TRANS/WP.29/GRE/2003/42
7 July 2003

PROPOSAL FOR DRAFT AMENDMENTS TO REGULATION No. 37
(Filament lamps)

Transmitted by the expert from the Working Party "Brussels 1952" (GTB)

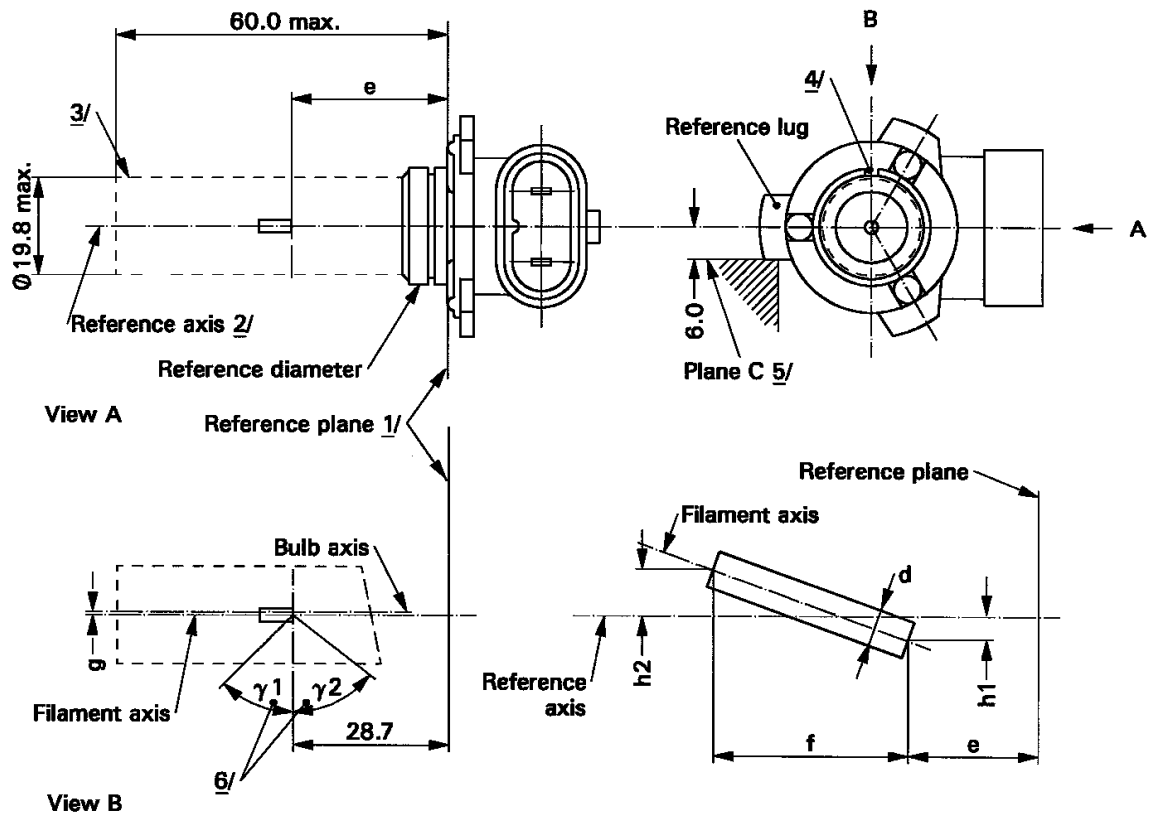
Sheets HIR2/1..3, replace by the new sheets HIR2/1..3; (see next pages)

For HIR2 an amendment of the dimension "e" is proposed. Parallel to this proposal, an amendment for HIR2 was proposed in the United States of America such that the eventual specifications of HIR2 are harmonized. The change of $e = 28.9$ mm into $e = 28.7$ mm was part of the drawings and a table, being difficult to edit; the new sheets HIR2/1..3, only differing in the value of "e", should replace the existing sheets.

Dimensions in mm <u>11/</u>		Tolerances		
		Filament lamps of normal production	Standard filament lamp	
e	<u>8/ 10/</u>	28.7	<u>9/</u>	± 0.16
f	<u>8/ 10/</u>	5.3	<u>9/</u>	± 0.16
g	<u>8/</u>	0	+ 0.7 / - 0.0	+ 0.4 / - 0.0
h1, h2		0	<u>9/</u>	± 0.15 <u>7/</u>
d		1.6 max.	-	-
γ1		50° min.	-	-
γ2		50° min.	-	-
Cap PX22d in accordance with IEC Publication 60061 (sheet 7004-32-2)				
ELECTRICAL AND PHOTOMETRIC CHARACTERISTICS				
Rated values	Volts		12	12
	Watts		55	55
Test voltage	Volts		13.2	13.2
Objective values	Watts		63 max.	63 max.
	Luminous flux		1875 ± 15 %	
Reference luminous flux: 1355 lm at approximately 12 V

Sheet WR21/5W/1

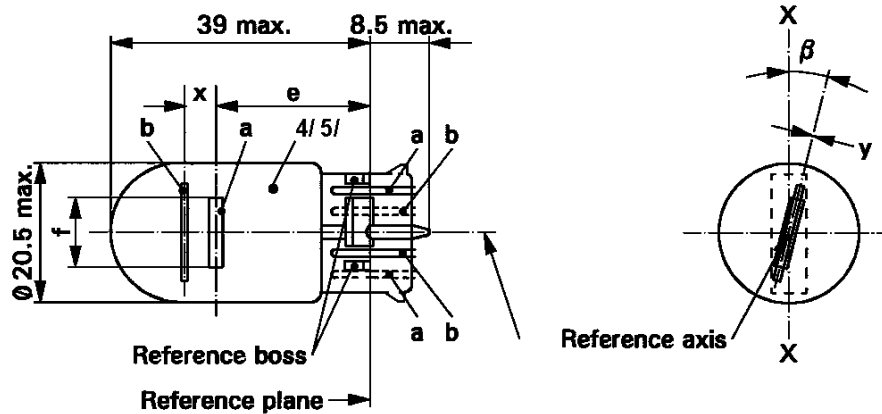
Insert new sheet WR21/5W/1 (between sheet WP21W/2 and sheet WY2.3W/1 as indicated in the list of sheets above), to read: (see next pages)

The proposed draft amendments concern the addition of a new red wedge base double filament lamp. It is a red version of the existing W21/5W.
